**RE: Updated Corrective Action Plan  
GP II Littlefield BO Federal #2 Battery (2RP-1738)  
UL/A sec. 34 T26S R29E  
API No. 30-015-24529**

### **Update Corrective Action Plan**

**Figure 1**

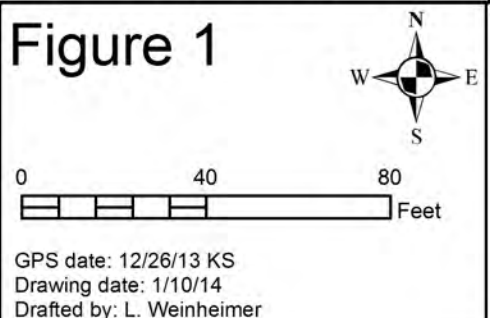
RECS personnel were on site beginning on September 6<sup>th</sup>, 2013 to assess the site. The stained area on the pad was scraped down to a depth of 1 foot and a 5 point composite of the bottom of the scrape was taken to a commercial laboratory for analysis (Figure 1 and Appendix C). The 5 point composite returned a laboratory chloride reading of 848 mg/kg and Gasoline Range Organics (GRO), Diesel Range Organics (DRO) and BTEX readings of non-detect. Vertical installation was attempted within the bermed battery area but had to be abandoned once an unmarked PVC pipe was discovered. Two samples were taken prior to the vertical being abandoned. The 4 ft sample returned a field chloride result of 12,497 mg/kg and the 5 ft sample returned a field chloride result of 2,100 mg/kg.

On December 26<sup>th</sup>, 2013, the previous vertical was extended to the north and with some effort, RECS was able to break through the rock and get samples at a depth of 5.5 ft and 6 ft (Figure 1). Both these samples were taken to a commercial laboratory and returned chloride values below 1,000 mg/kg (Appendix D). Another vertical was installed to the northeast and determined that rock was located there as well. This data was sent to BLM and NMOCD on January 15<sup>th</sup>, 2014. BLM replied to this data by requesting a site visit with RECS and NMOCD on January 22<sup>nd</sup>, 2014.
